The Proposed Long Valley Road Extension through the Warner Ridge/Fort Pearce Area of Critical Environmental Concern (ACEC)

Long Valley Road Extension Issues (reference maps and photos follow)

The Long Valley Road Extension Context and Detail Maps

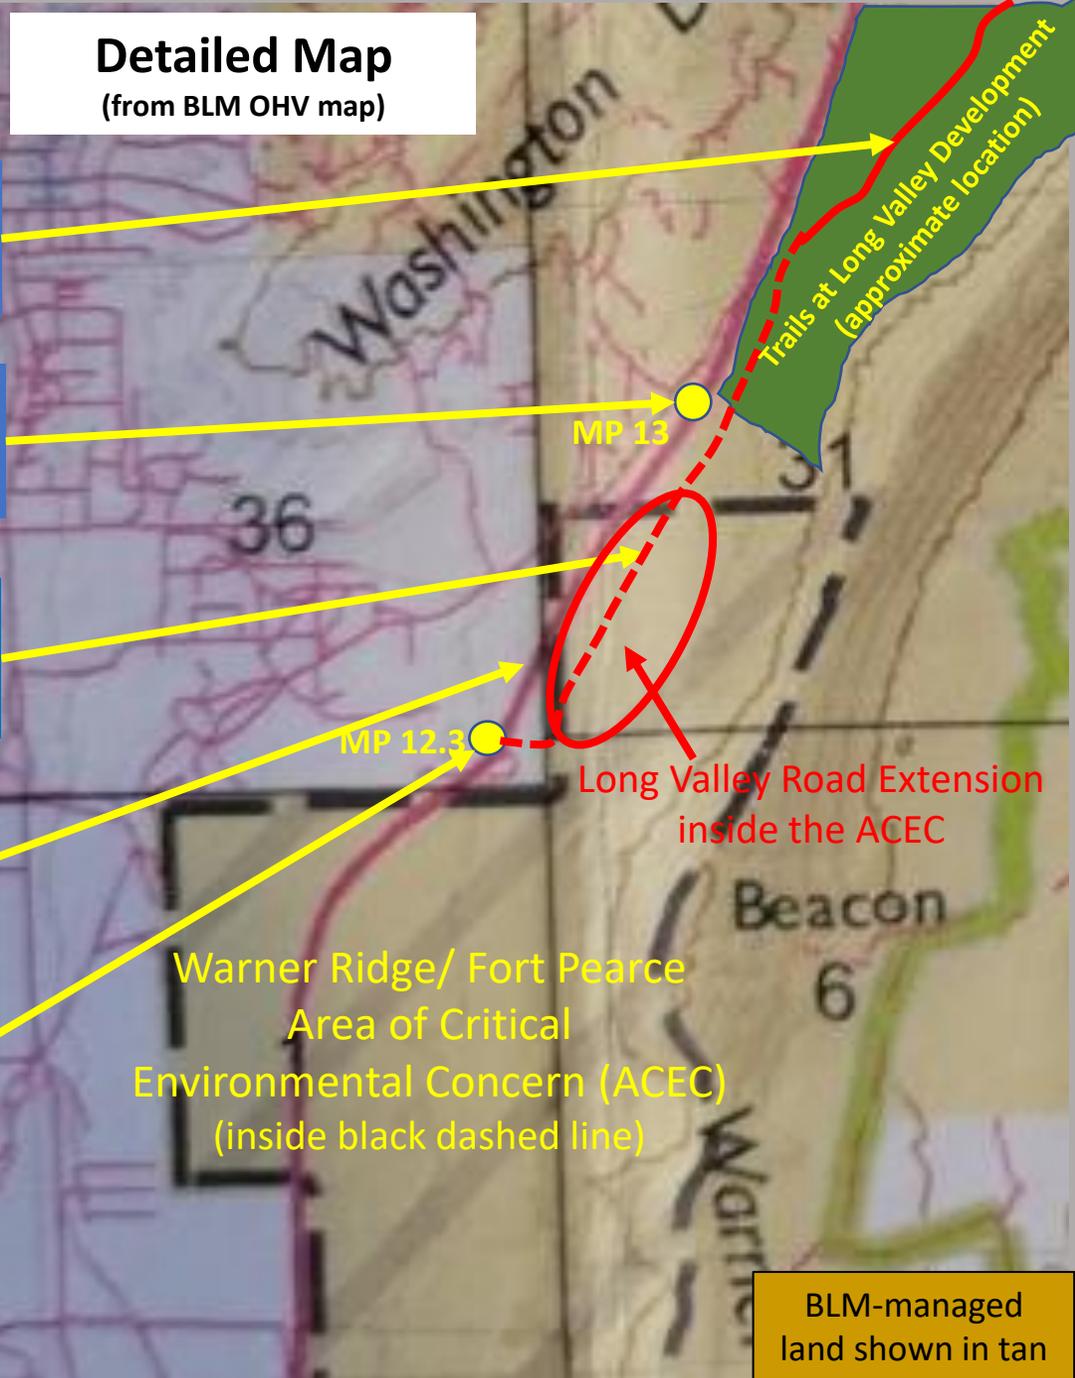
CSU Proposed Alternative Location for New Interchange (see photos 1 and 2)

Planned Long Valley Road Extension through the ACEC (2nd access to development)

Planned New Interchange Near MP 12 (~12.3) (see photo 3)

Long Valley Road Extension Area - topography

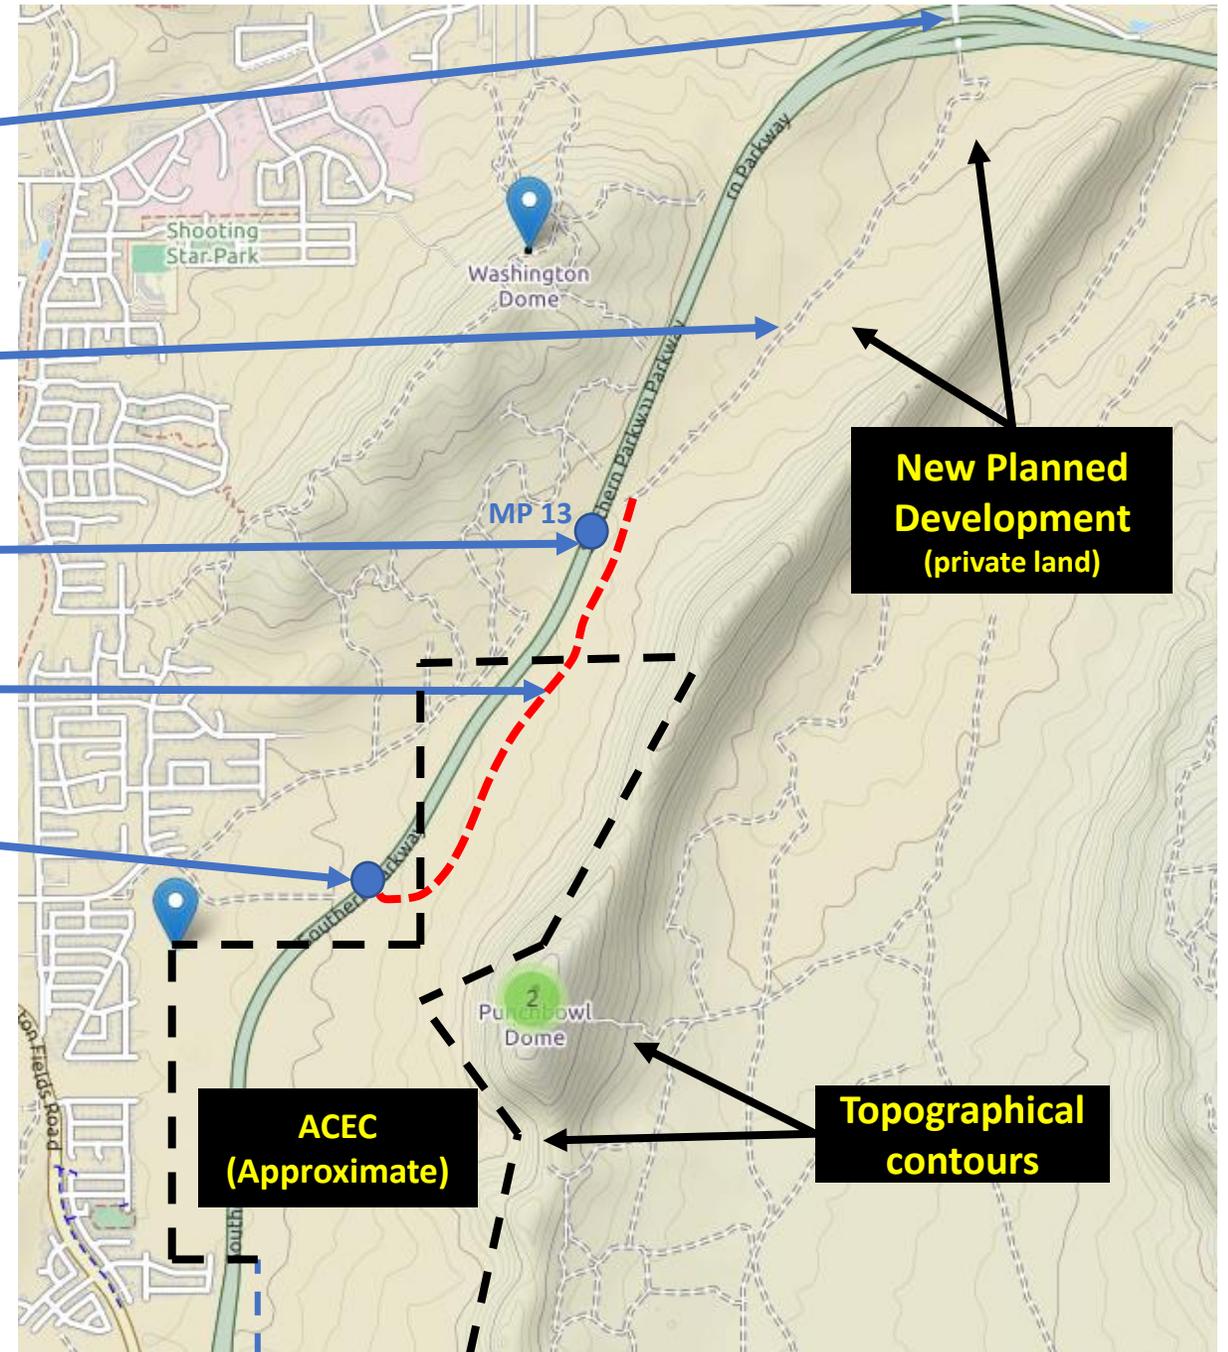
Observation: the topography around the interchange position proposed by CSU near MP 13 is not substantially different than that around the planned interchange position near mile-mark 12.3

Note the absence of major topographical contours along SR-7 and possible interchange locations, indicating flat topography

**Map 2: Detail of the Proposed ROW
Extending Long Valley Road
to the Planned Interchange near MP 12
(based on EA Figure 1)**

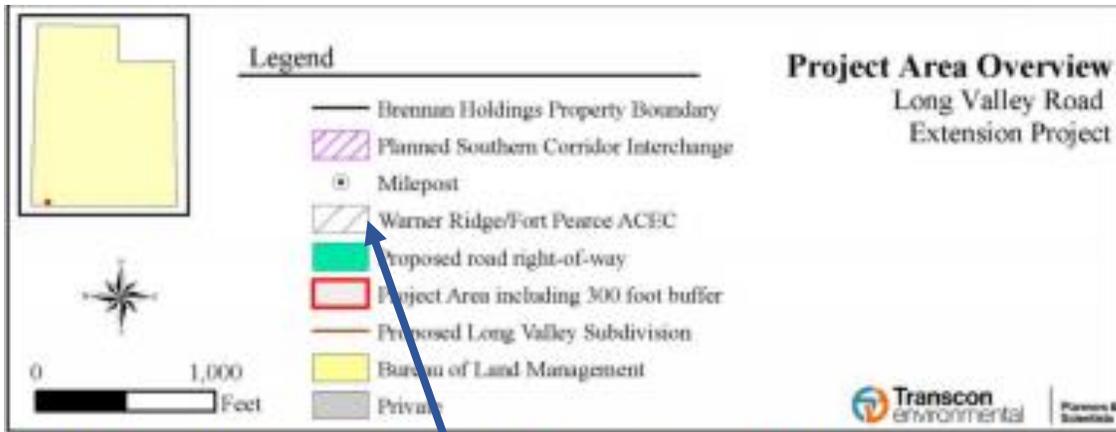
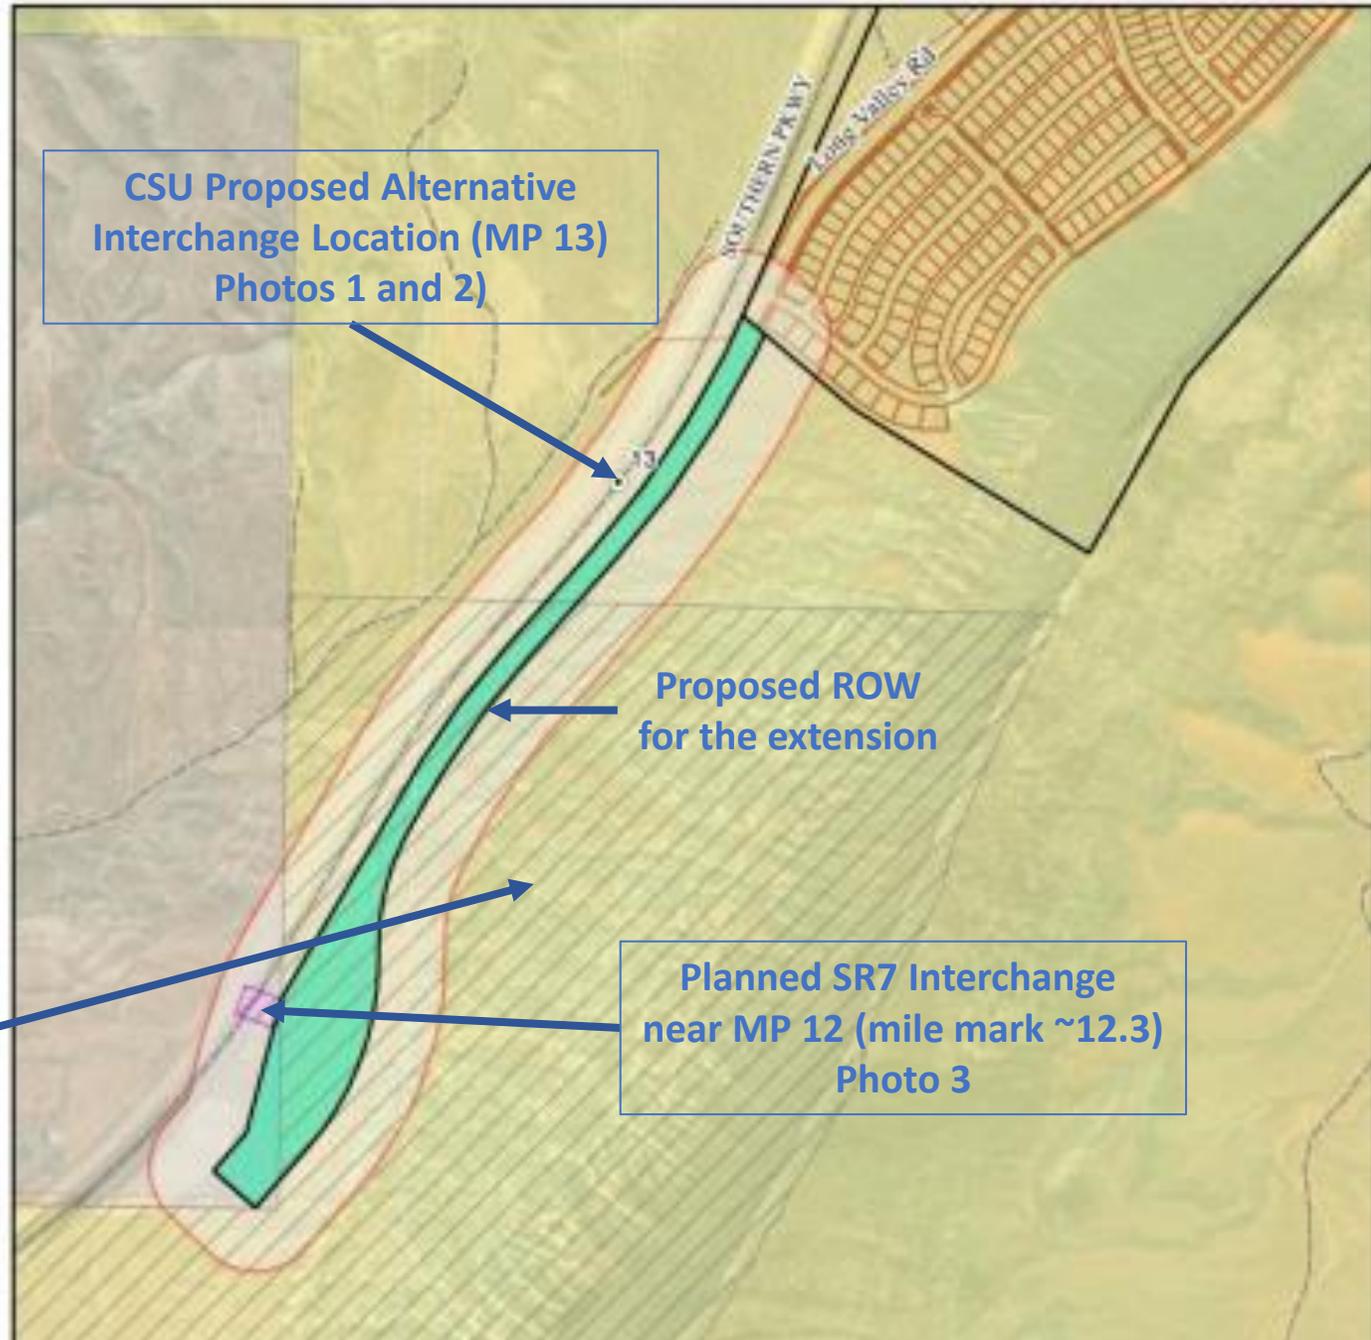
**The ACEC
(striped area)**

* Planned interchange MP identifier corrected from EA Comments
